# 8150 Sunset: Golder Response to 6.29.15 LADBS Geology and Soils Report Correction Letter

**RE: RESPONSE TO THE JUNE 29, 2015 CITY OF LOS ANGELES GEOLOGY AND SOILS  
REPORT CORRECTION LETTER  
PROPOSED RESIDENTIAL AND COMMERCIAL DEVELOPMENT  
8150 SUNSET BOULEVARD, LOS ANGELES, CALIFORNIA**

- "Geology and Soils Report Correction Letter," Log # 83343-01 for Tentative Tract 72370 at 8150 West Sunset Boulevard, dated June 29, 2015.

**FIGURE 1**

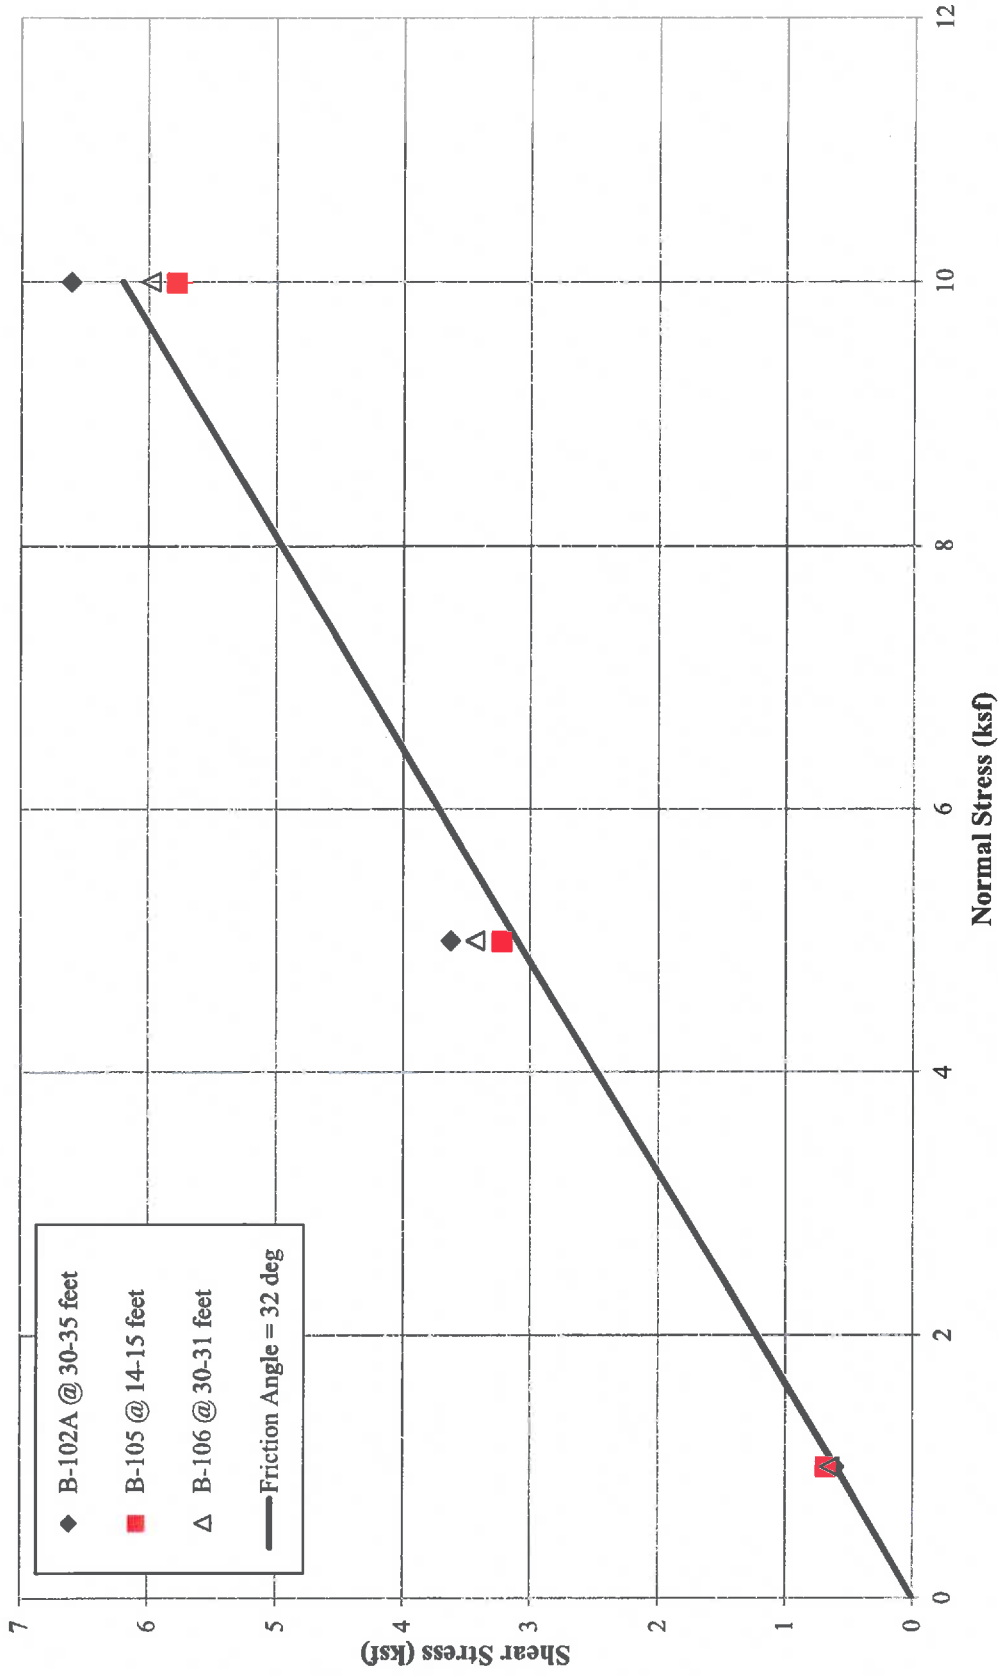
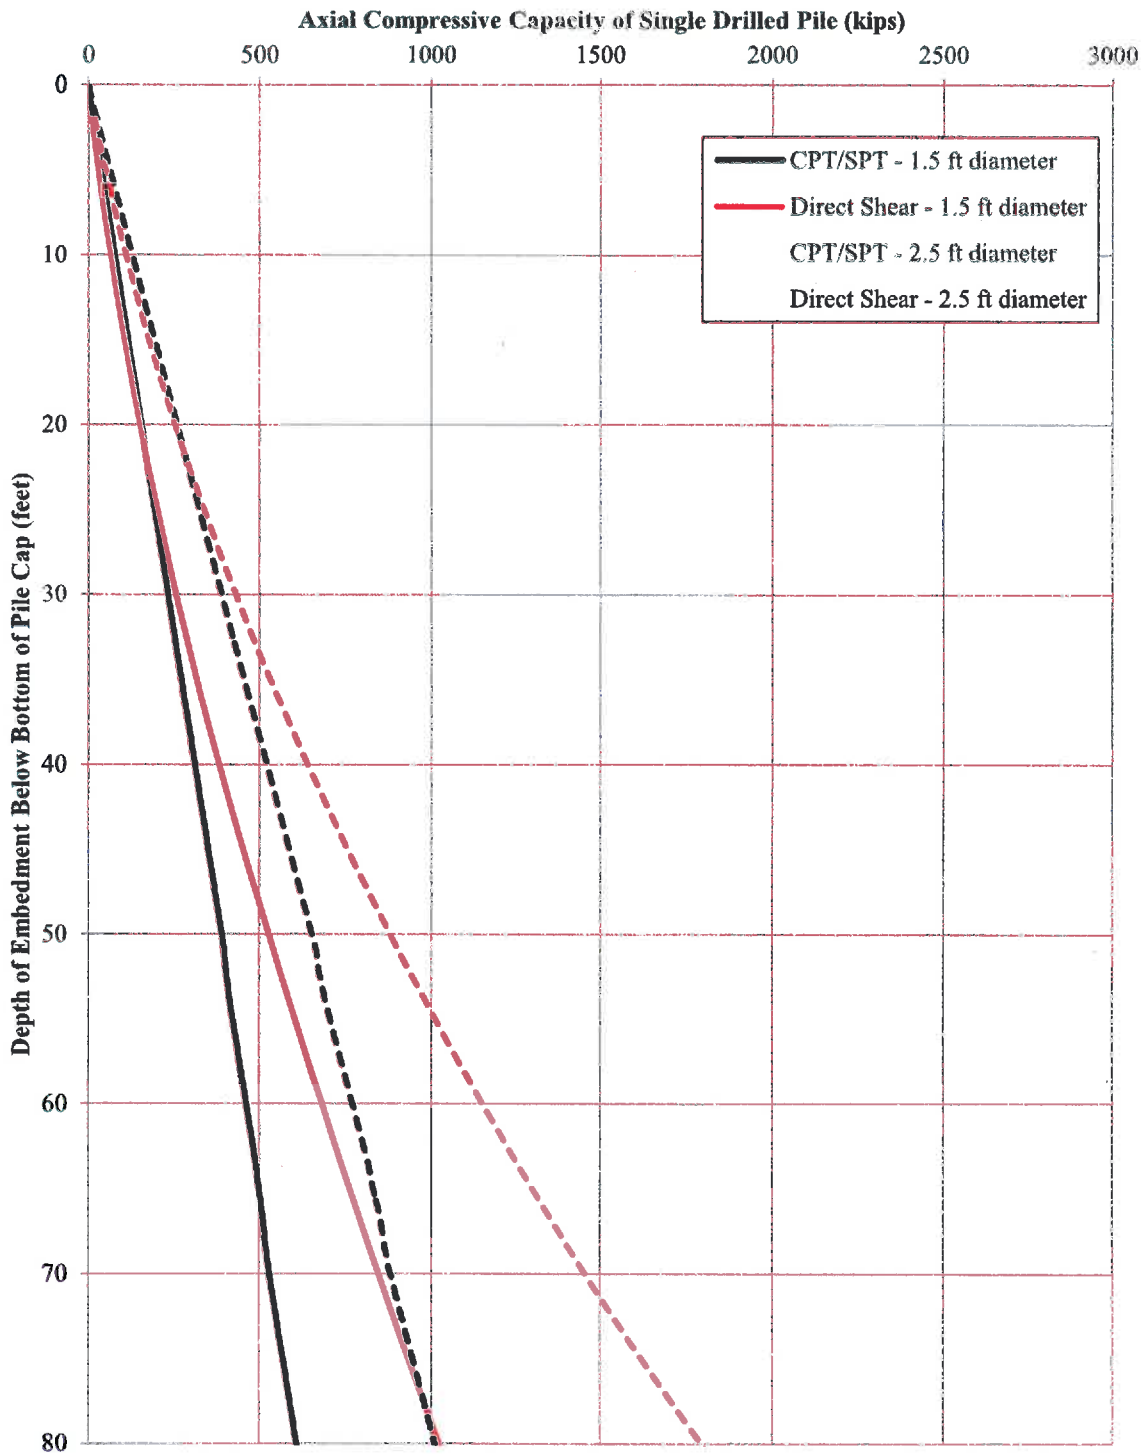
*Based on the figure titled "Cross Section Locations" in the response report, a proposed structure is located at the northwest corner of the site. Provide geologic exploration 50 feet northwest of the structure (offsite) to determine the possible existence of an active fault within 50 feet of its planned location. Alternatively, show a setback area (building exclusion zone) or reinforced foundation zone on all site plans included in the reports.*

Golder gathered continuous core samples in boring B-106 on November 20, 2013 at a location approximately 29 feet south of the intersection of Havenhurst Drive and Sunset Boulevard, as shown on

Figure 1 to this letter. Soil samples were collected as part of Golder's fault rupture hazard assessment of the Hollywood Fault at the site, as described in Golder's Fault Hazard Report. In addition, Golder performed cone penetration test (CPT) sounding CPT-14 immediately north of boring B-106, as shown on Figure 1 to this letter. Golder's fault hazard study established that the main trace of the Hollywood Fault is located northwest of B-106 and CPT-14. However, Golder's fault rupture investigation was unable to extend 50 feet beyond the site's boundary because of access and traffic restrictions on Sunset Boulevard. While the State of California Alquist-Priolo map shows the main trace of the Hollywood Fault more than 100 feet northwest of the site's northwest corner (see Figure 1 to this letter), our investigation was unable to unequivocally establish that the main Hollywood Fault trace is more than 50 feet from the northwest corner of the site.

In light of the above, Golder has followed the City's policy and established a 50-foot wide reinforced foundation zone in the northwest corner of the site as shown on Figure 1 to this letter. This zone does not contain the main trace of the Hollywood Fault, but could be subject to secondary surface fault rupture or off-fault displacements. Secondary fault rupture displacements are expected to be less than the displacements on the main Hollywood Fault trace that is located an unknown distance northwest of the reinforced foundation zone.

Figure 1 to this letter presents a composite site map showing the proposed reinforced foundation zone, the location of the main trace of the Hollywood Fault, the extents of the Alquist-Priolo Earthquake Fault Zone, CPT and boring locations, and the approximate limits of the proposed basement excavation and building development. Figure 1 to this letter is also included in Addendum No. 1 to Golder's Geotechnical Report along with the above-described recommendations for the reinforced foundation zone.

**FIGURE 1**

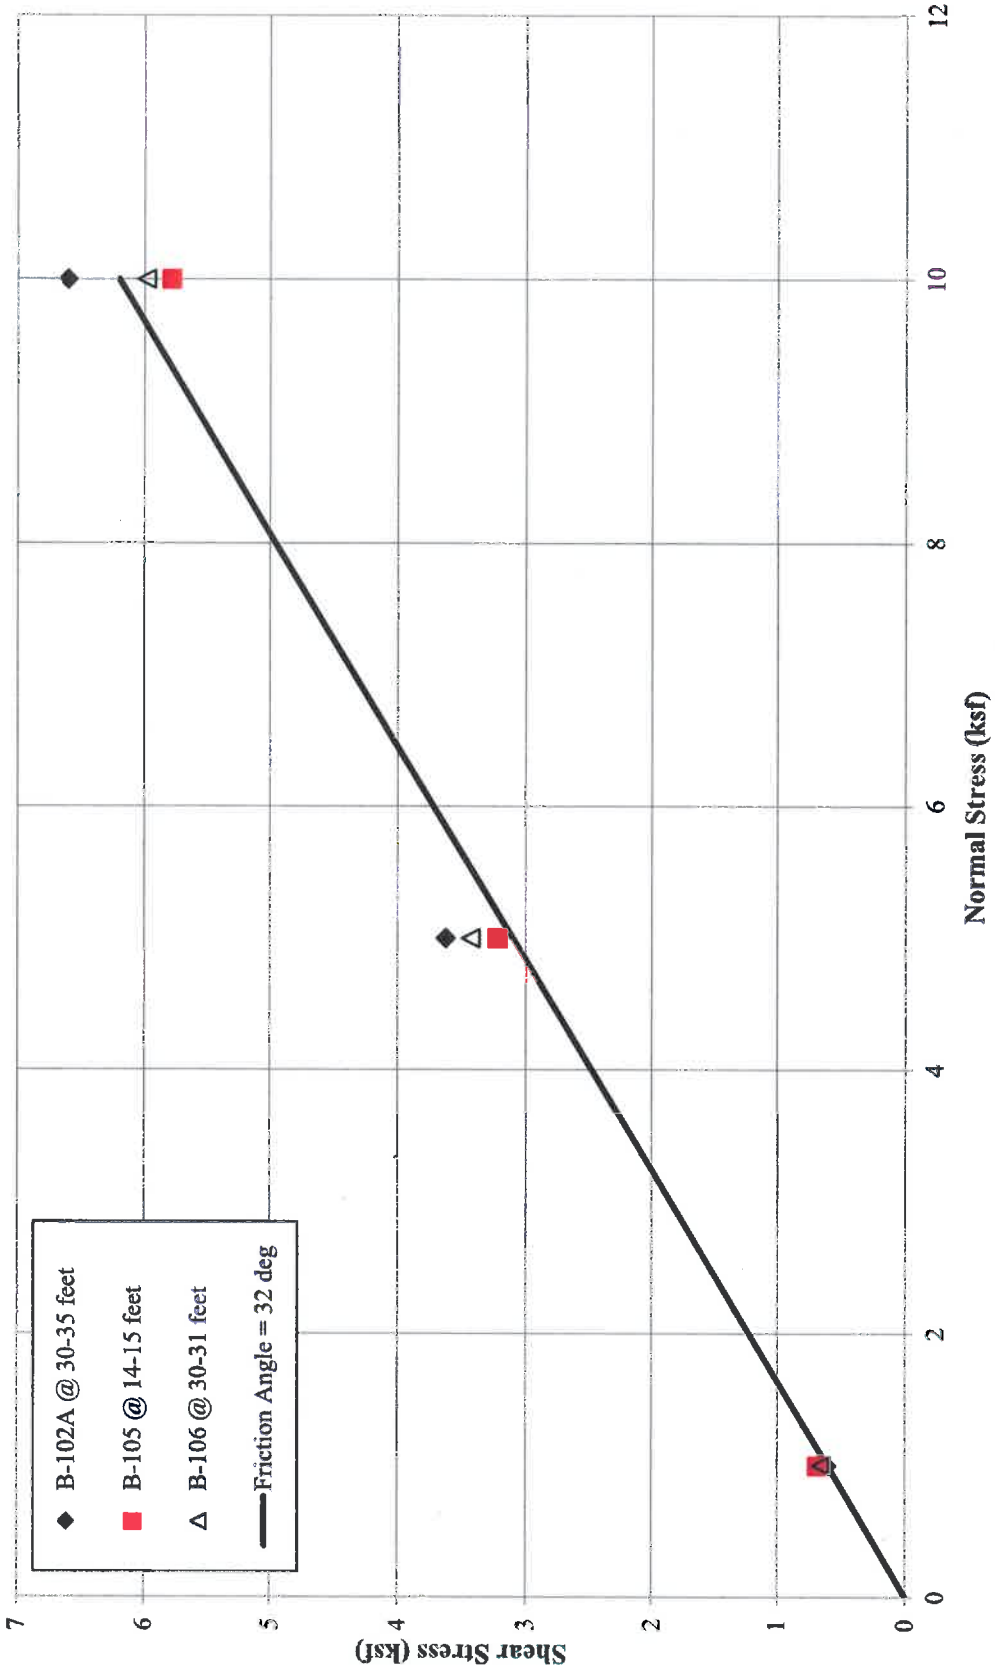
1. Based on the figure titled "Cross Section Locations" in the response report, a proposed structure is located at the northwest corner of the site. Provide geologic exploration 50 feet northwest of the structure (offsite) to determine the possible existence of an active fault within 50 feet of its planned location. Alternatively, show a setback area (building exclusion zone) or reinforced foundation zone on all site plans included in the reports.

Golder's fault hazard study for the site (Golder, 2015<sup>1</sup>) established that the main trace of the Hollywood Fault is located northwest of boring B-106 and cone penetration test (CPT) sounding CPT-14 (see Figure 1 to this letter). However, Golder's fault rupture investigation was unable to extent 50 feet beyond the site's boundary because of access and traffic restrictions on Sunset Boulevard. While the State of California Alquist-Priolo map shows the main trace of the Hollywood Fault more than 100 feet northwest of the site's northwest corner (see Figure 1 to this letter), our investigation was unable to unequivocally establish that the main Hollywood Fault trace is more than 50 feet from the northwest corner of the site. Therefore, in accordance with City of Los Angeles policy, Golder recommends that a 50-foot wide reinforced foundation zone be established in the northwest corner of the site as shown on Figure 1 to this letter (Figure 1 also shows the location of the main trace of the Hollywood Fault, the extents of the Alquist-Priolo Earthquake Fault Zone, CPT and boring locations, and the approximate limits of the proposed basement excavation and building development).

**FIGURE 2**  
**Results of Direct Shear Tests**  
 8150 Sunset Boulevard, Los Angeles, California

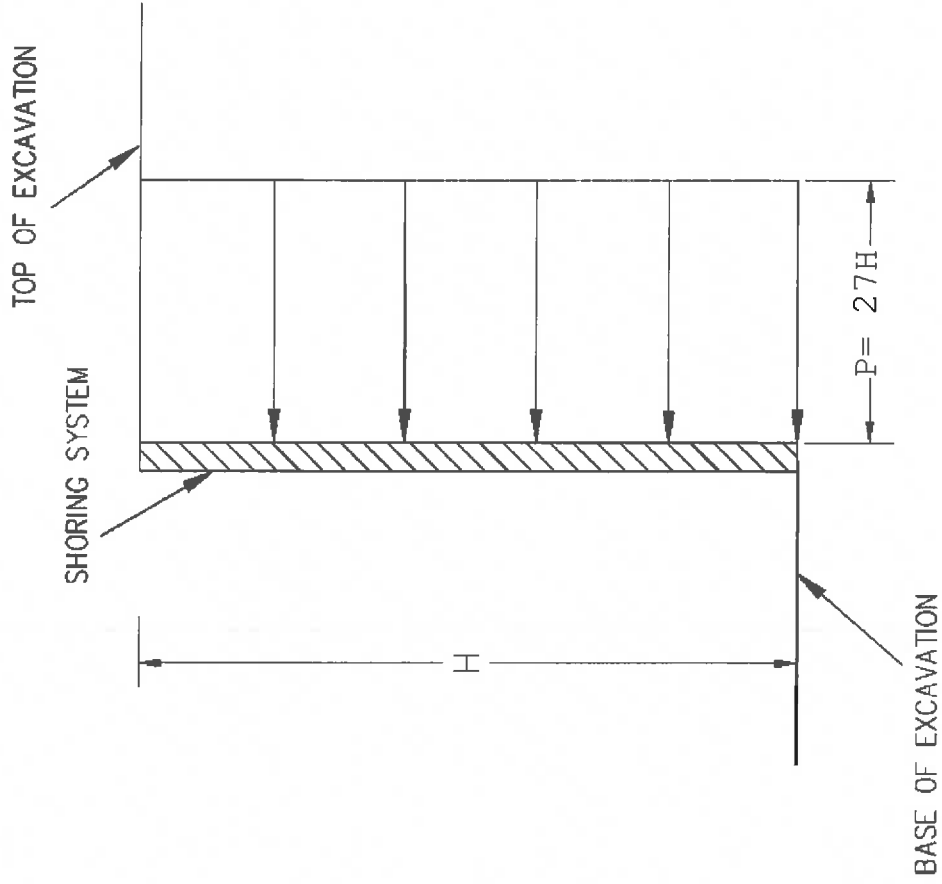
*Regarding the response to Comment 6, the Department does not allow estimation of shear strength parameters for analyses. In addition, the values presented for widths less than 10 feet are much higher than calculated by Terzaghi's bearing capacity equation. Provide bearing capacities based on direct shear testing (3-points minimum) correctly calculated. Provide settlement analyses. Alternatively, use Code bearing values.*

*Comment 10 on the relatively low blow count data was to question the bearing capacity values recommended. The Department does not allow determination of the internal angle of friction, bearing capacities and pile skin friction by SPT or CPT data. Determine bearing capacity and/or skin friction by direct shear test results.*

*Regarding the response to Comment 11, the Department does not accept SPT/CPT derived shear strengths in long-term slope stability and retaining wall analyses. Provide saturated direct shear test data on the earth material to be retained, and utilize the saturated unit weights of earth materials in long-term slope stability and retaining wall analyses where these result in more critical computed factors of safety. (P/BC 2014-049)*

Figure 2 to this letter presents a summary plot of shear stress at failure (i.e., shear stress at the end of the direct shear tests) versus normal stress for each of the three sets of direct shear tests. Figure 2 also shows a conservative best-fit linear failure envelope for the direct shear test data, with the cohesion intercept set at zero (which is appropriate for the granular soils at the site). As can be seen on Figure 2, the conservative best-fit linear failure envelope for the direct shear test data corresponds to a friction angle of 32 degrees (with a cohesion intercept of zero). Figure 2 and Attachment B to this letter are included in Addendum No. 1 to Golder's Geotechnical Report.

As described in Section 4.4 of Golder's Geotechnical Report, a friction angle of 32 degrees (with zero cohesion) was used in the calculation of bearing capacities of shallow foundations. Based on the direct shear laboratory test results described above and summarized on Figure 2, use of a friction angle of 32

As discussed in the response to comment 4 above, the results of laboratory direct shear tests on subsurface soils from the site, which are summarized in Figure 2 to this letter, have corroborated the friction angle of 32 degrees that was used to develop the allowable bearing pressures for shallow foundations that are given in Section 4.3.2 of Golder's Geotechnical Report. Therefore, the allowable bearing pressures in Section 4.3.2 of Golder's Geotechnical Report are valid.

As discussed in the response to comment 4 above, the results of direct shear tests on subsurface soils from the site, which are summarized in Figure 2 to this letter, have corroborated the friction angle value of 32 degrees that was used to develop the lateral earth pressure recommendations in Section 4.5 of Golder's Geotechnical Report. Therefore, based on the results of the direct shear tests, the lateral earth pressures provided in Golder's Geotechnical Report are valid.

**FIGURE 3**  
**APPARENT EARTH PRESSURE DISTRIBUTION FOR BRACED AND TIED-BACK EXCAVATIONS**  
8150 Sunset Boulevard, Los Angeles, California

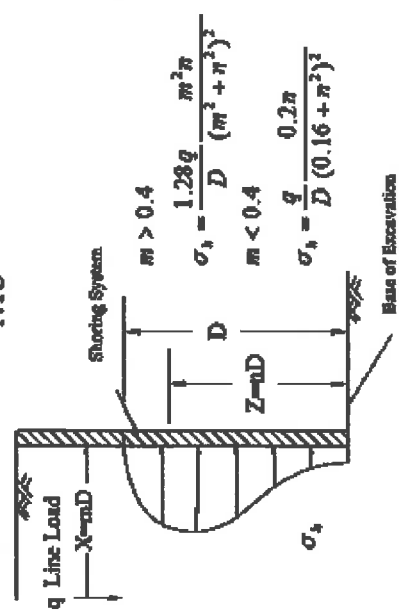
*Regarding the response to Comment 13, provide recommendations for shoring, including the lateral earth pressure shoring is the retaining.*

*Where an excavation would remove lateral support (as defined in Code Section 3307.3.1) from an adjacent public way, property or structure, provide analysis demonstrating that shoring has an acceptable factor of safety ( $FS \geq 1.25$ ) against failure based on the shear strength parameters of the earth materials the shoring is to support, at the most critical degree of saturation that is expected to occur. All surcharge loads shall be considered. (P/BC 2014-113)*

Figure 3 shows the apparent earth pressure distribution that is recommended for shoring design. The recommended uniform apparent pressure distribution for sandy soils conforms to the standard practice in geotechnical engineering based upon measured strut loads in deep excavations. The cantilever portion of the wall down to the depth excavated to install the first brace/ground anchor should be checked separately using an equivalent fluid pressure of 39 pcf.
